# **FINAL DRAINAGE REPORT**

## **KANG STORAGE – 11401 E. HIGHWAY 24 LOT 1, ABIDING WORD LUTHERAN CHURCH SUBDIVISION**

**JPS Project No. 022601  
PCD Filing No. PPR26** 20

## Routed Hydrograph Results

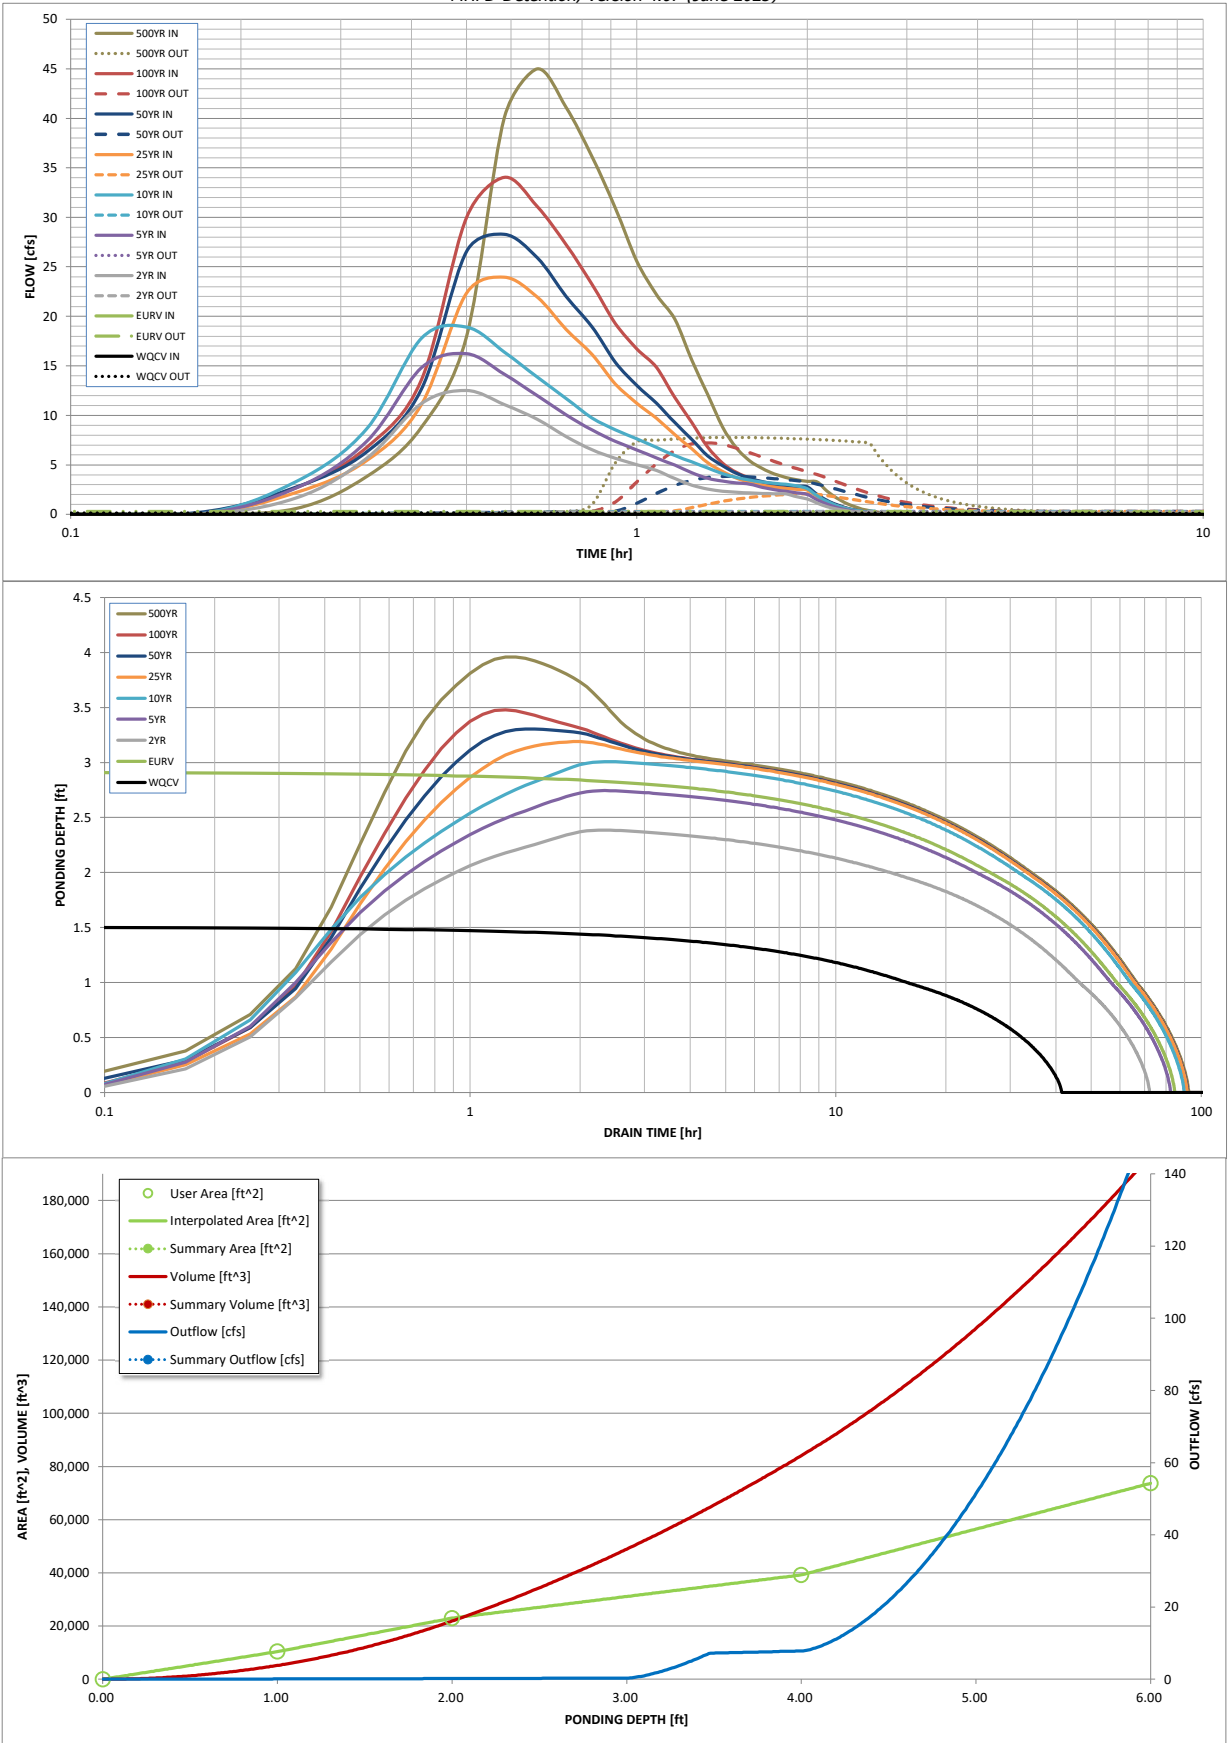
Time to Drain 97% of Inflow Volume (Hours): This does not meet the drain time requirements indicated in Senate Bill 15-212. Please revise accordingly.

EXISTING CONDITIONS  
DRAINAGE PLAN

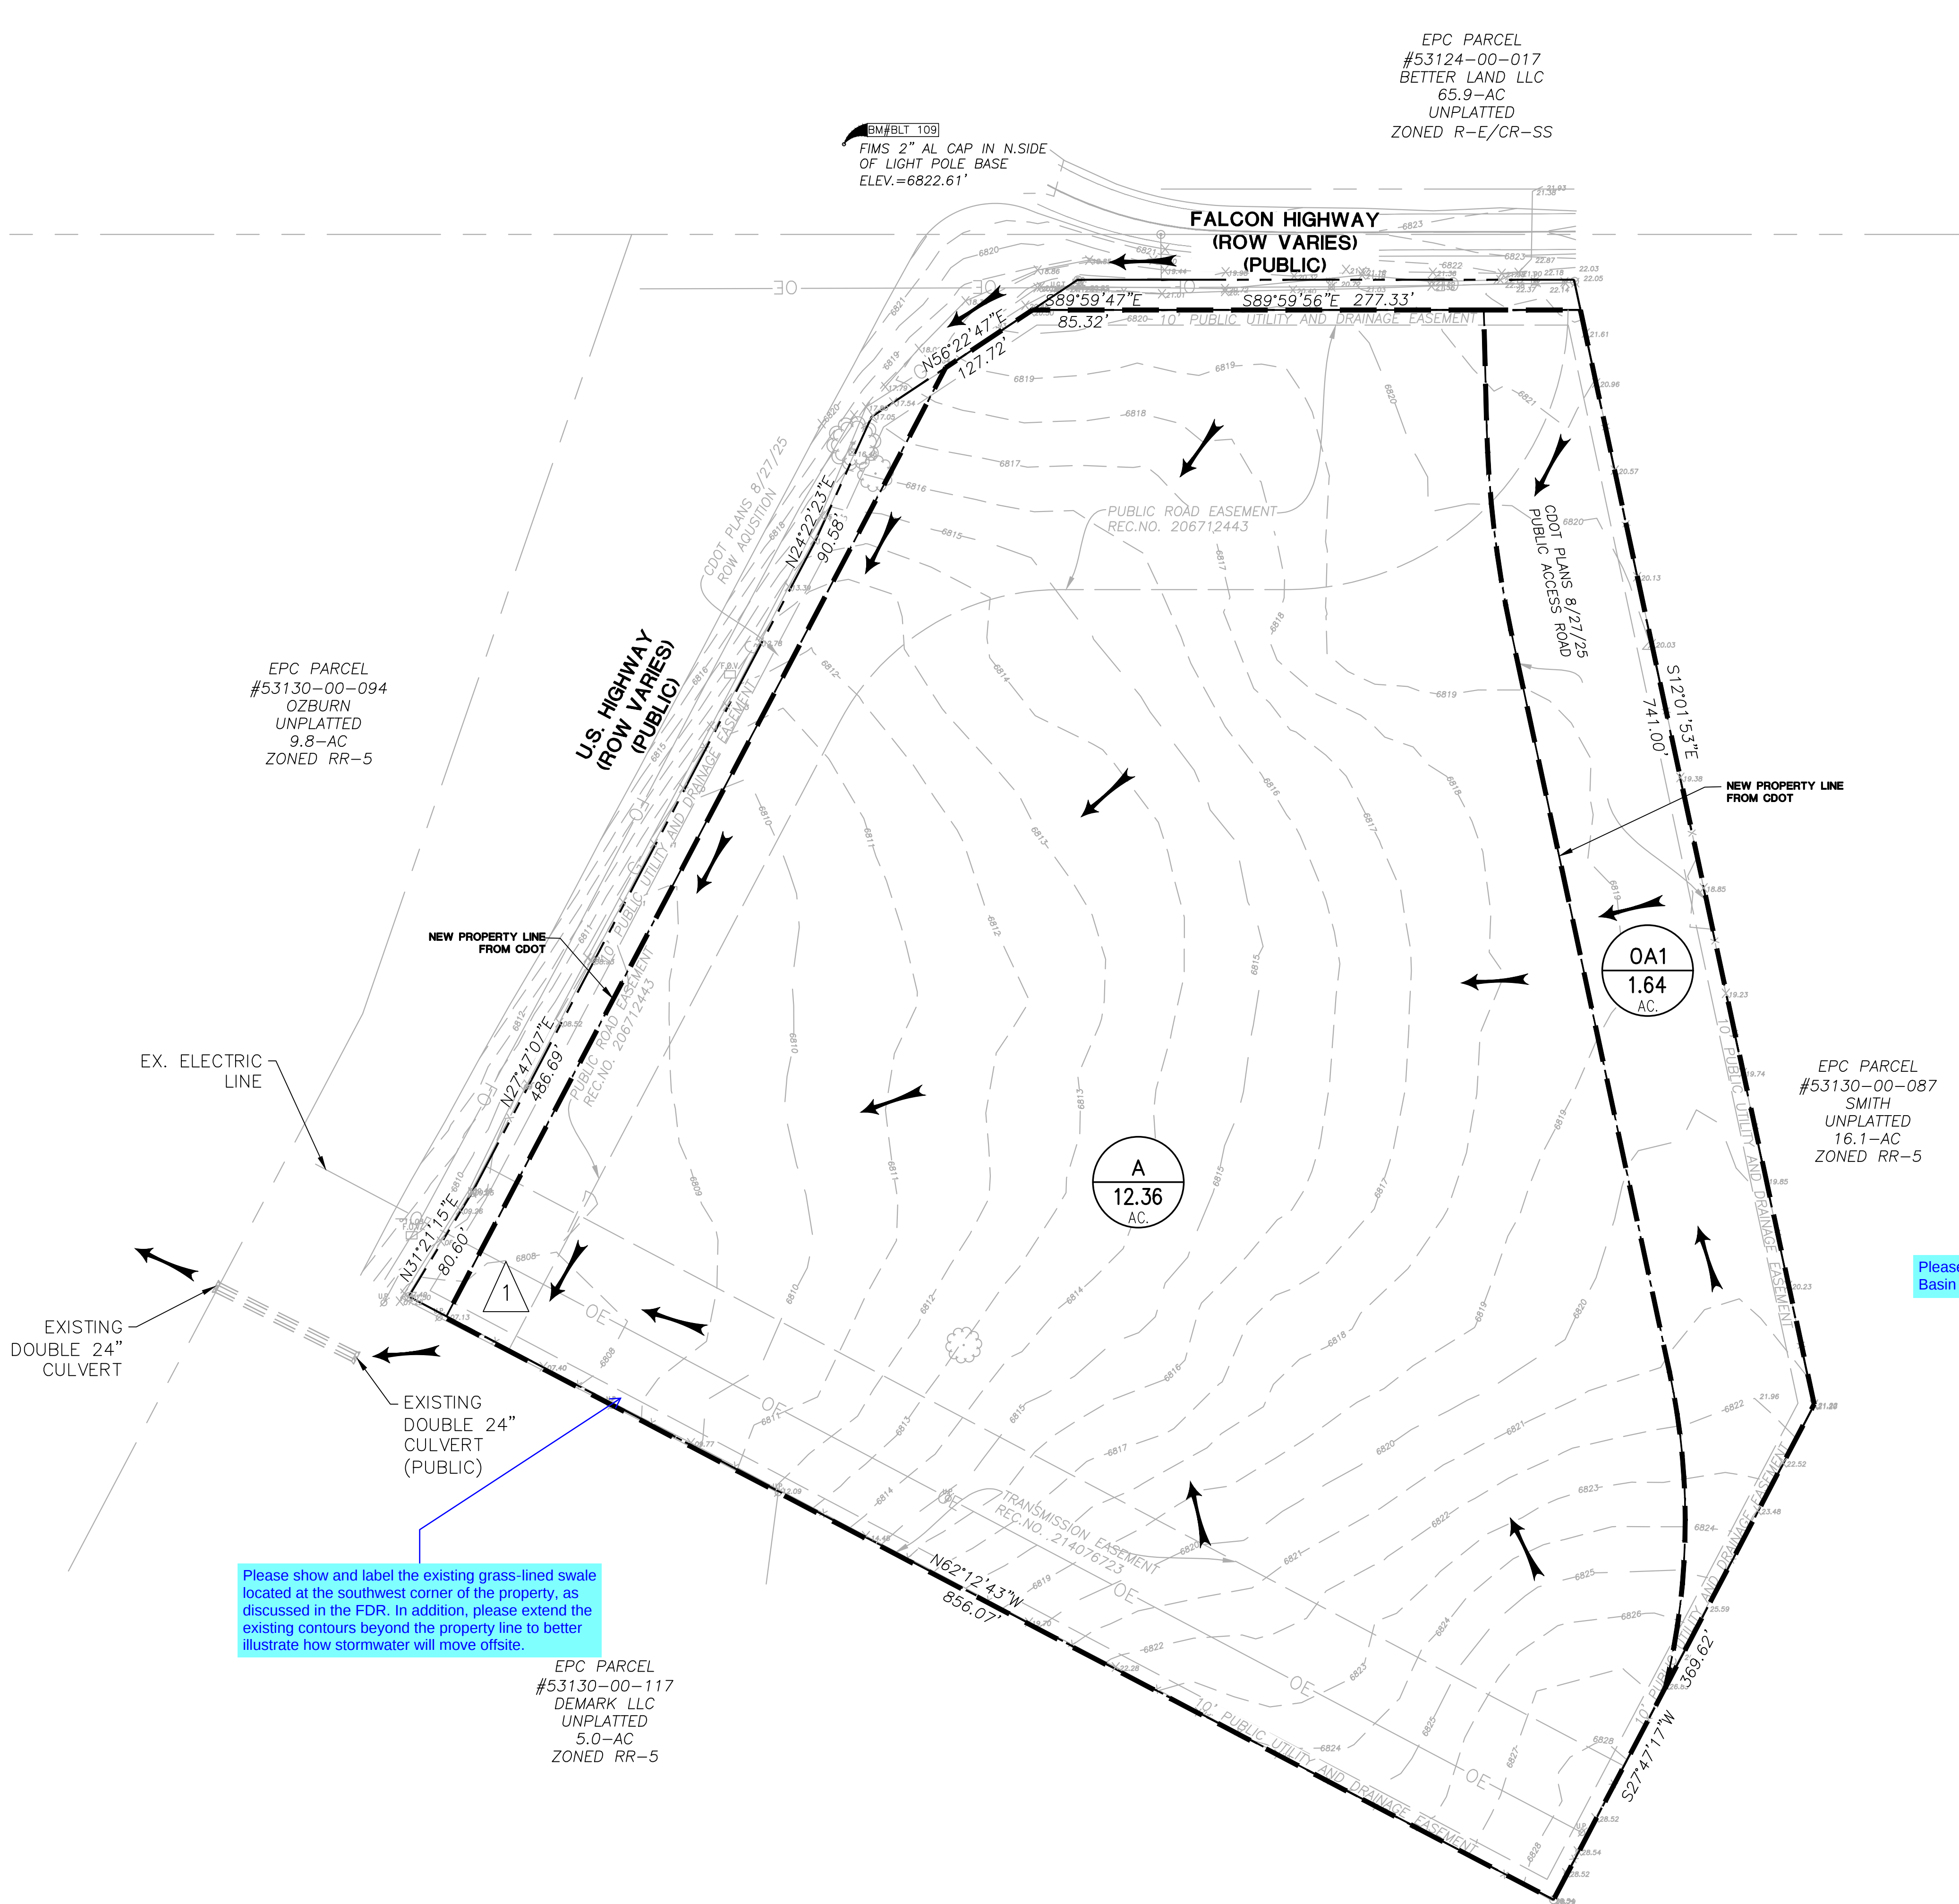
Please show path(s) chosen for computation of time of concentration for both the existing conditions drainage plan and developed conditions drainage plan.
